UNITED STATES PATENT AND TRADEMARK OFFICE

APPLICATION NO.	FILING DATE	FIRST NAMED INVENTOR	ATTORNEY DOCKET NO.	CONFIRMATION NO.
10/810,452	03/26/2004	Sehat Sutardja	MP0467	8949
26703	7590	06/15/2005	EXAMINER	
HARNESS, DICKEY & PIERCE P.L.C. 5445 CORPORATE DRIVE SUITE 400 TROY, MI 48098			VU, BAO Q	
			ART UNIT	PAPER NUMBER
			2838

Office Action Summary

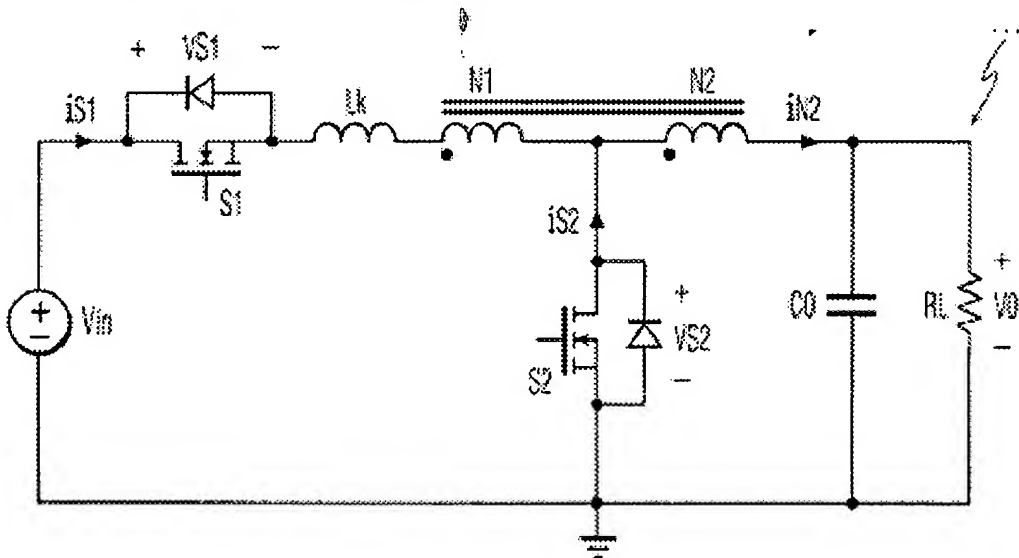
2. Claims 1, 2, 5, 6, 9, 11, 12, 15, 16, 19, 21 and 23 rejected under 35 U.S.C. 102(b) as being clearly anticipated by Qian (USP 6,512,352). Qian discloses the claimed invention a coupled inductor with first, N1, and second, N2, windings connected in series to form a common node, a conduction switch, S1, and a freewheeling switch, S2, the inductor is formed on a single core, and an output capacitor, Co. See figure below.
